To: Howard Resnik, PE
From: Jeff Walton, Associate Planner; 910-341-3260
CC: File; Protrak
Date: 8/26/2014
Re: Pier 33 – 715 Nutt Street

The following is a list of comments for review from planning regarding the project. Please provide your corrections as listed below. Additional review will be required once all the needed documents have been provided. Items or documents not provided on initial submission will be subject to further review. Please contact me for any further questions.

NUTT STREET ELEVATION
SCALE: 1" = 30'-0"

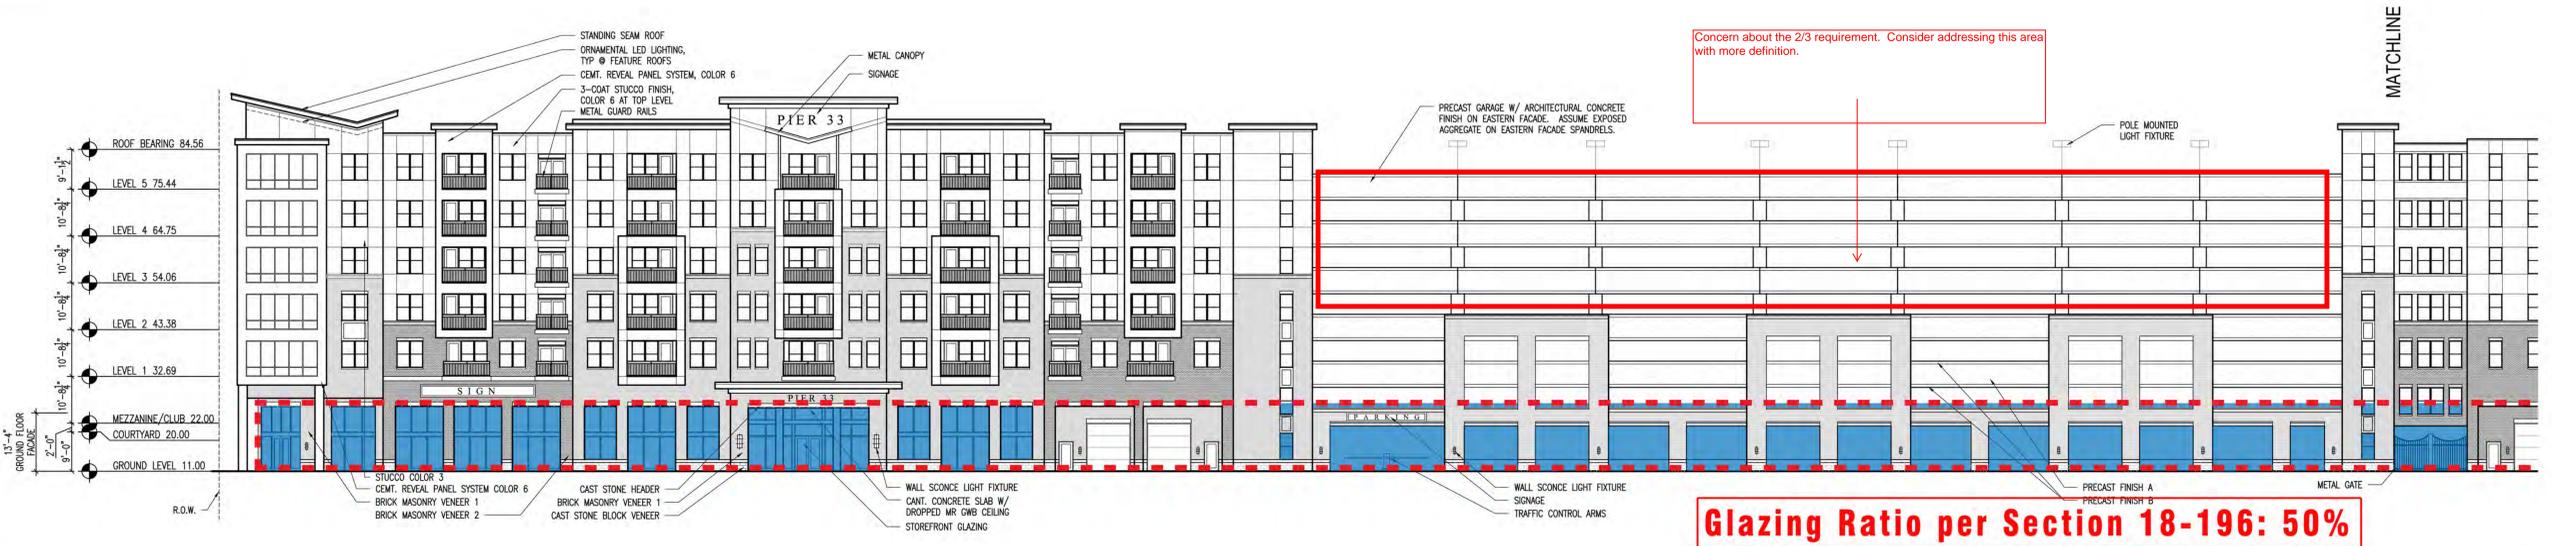
- The improvements of the large M's are great. I think you are fine with the bottom levels. I do have concerns with the upper levels of the deck. Is there a way to accent the upper floors to compliment the larger M's along Nutt Street. See redline.

BOARDWALK ELEVATION 1
 SCALE: 1" = 30'-0"

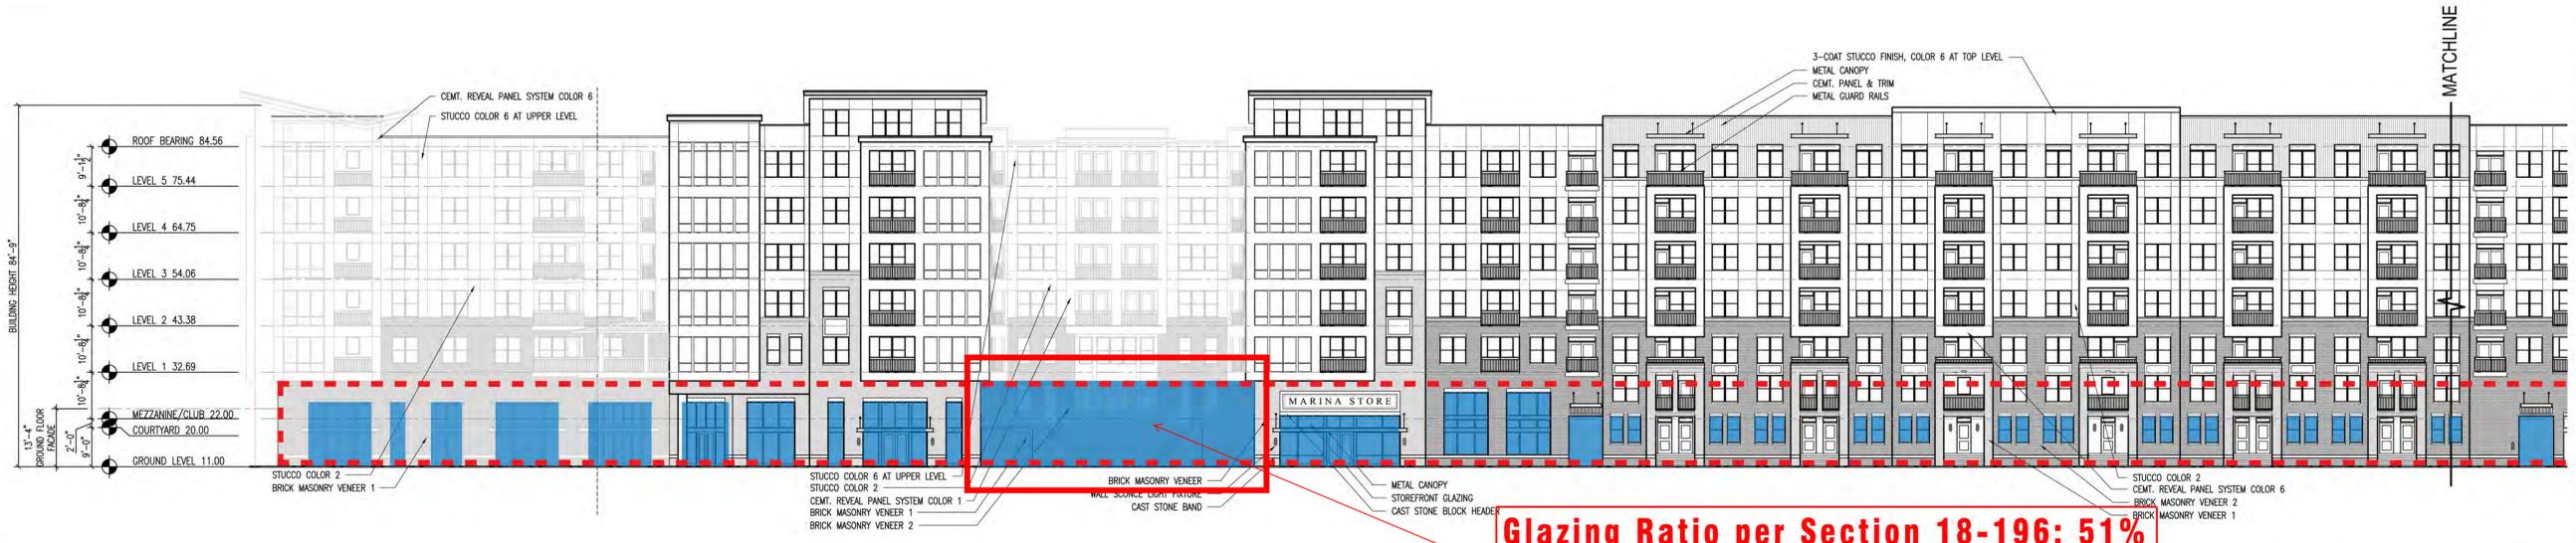
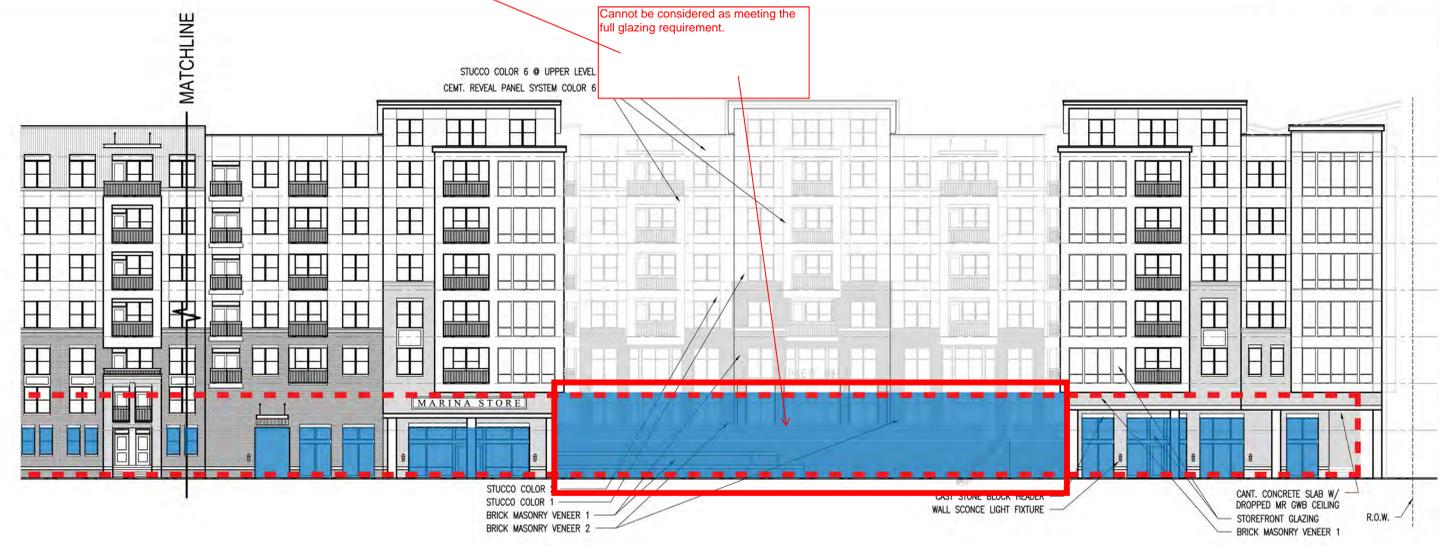
- Label for compliance on the elevation sets along the riverwalk.
 - I can agree with all the glazing except for the elevated patio areas. We cannot include these areas as compliance for the glazing.

- Can you consider adding glass to these areas under the patios for advertising or art display windows? I don't have much of a suggestion for these areas to comply with glazing.

Cannot be considered as meeting the full glazing requirement.
